# Service Bulletin

Bulletin No. 2018-01  
OEM No. 2018-01

## 30/35/40/50/60 HP FourStroke Fuel Pump Replacement

66984

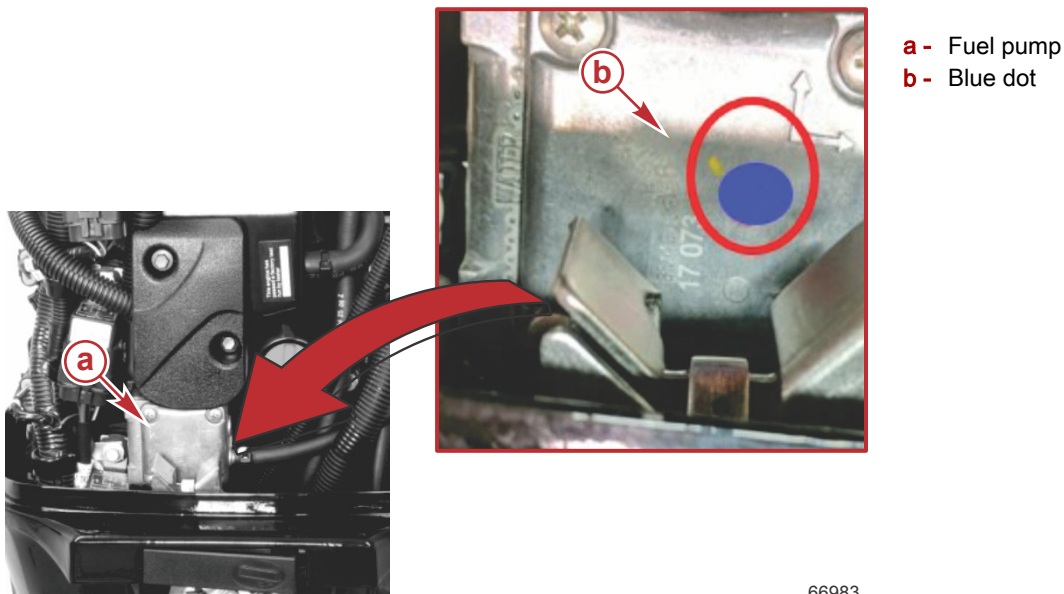
1. A blue dot on the engine's shipping container indicates that the fuel pump was inspected at the factory. No further action is required.

66983

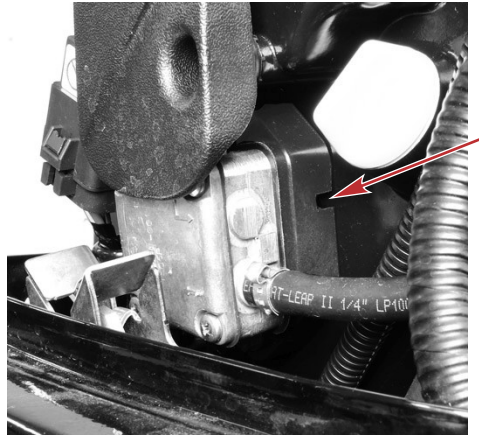
2. A blue dot on the rear face of the fuel pump indicates that the fuel pump has been replaced. No further action is required.

1. Complete the inspection and replace the fuel pump if a blue dot was not found. Refer to the appropriate table in the **Parts Required** section of this bulletin. See the service manual for the fuel pump removal and installation procedures.
2. Use a blue paint marker and place a blue paint dot on the rear face of the fuel pump to indicate that the fuel pump has been replaced. No further action is required.

65194

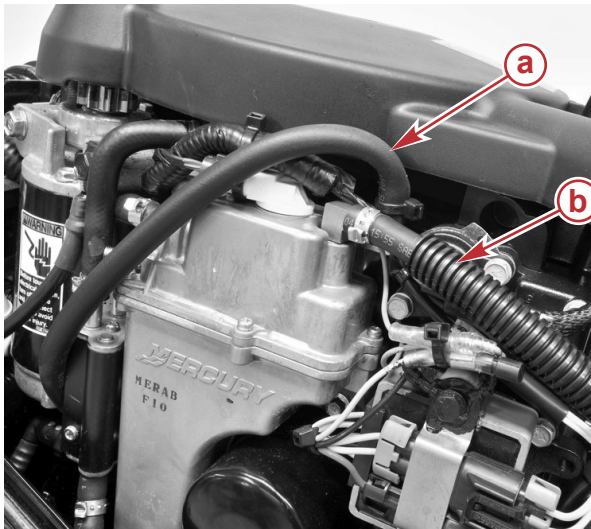
1. Connect the fuel line to the engine and prime the fuel system with the primer bulb.
2. While applying pressure to the primer bulb, inspect the fuel pump area for fuel leakage. Look carefully at the diaphragm area and the vent opening where the fuel pump contacts the camshaft cover.

3. If there is fuel weeping from the fuel pump vent opening, remove the vapor separator tank (VST) vent hose.

4. If there is fuel exiting the VST vent:
  - a. Replace the VST, the VST fuel hose, and the fuel pump. Refer to **Repair B—Fuel Pump and VST Replacement for EFI Engines** in the **Parts Required** section of this bulletin. See the service manual for the removal and installation procedure.
  - b. Use a blue paint marker and place a blue paint dot on the rear face of the fuel pump to indicate that all fuel system corrections are complete. No further action is required.

5. If there is no fuel exiting the VST vent:
- Replace the fuel pump. Refer to **Repair A—Fuel Pump Only Replacement for EFI Engines** in the **Parts Required** section of this bulletin. See the service manual for the removal and installation procedure.
  - Use a blue paint marker and place a blue paint dot on the rear face of the fuel pump to indicate that the fuel pump has been replaced. No further action is required.
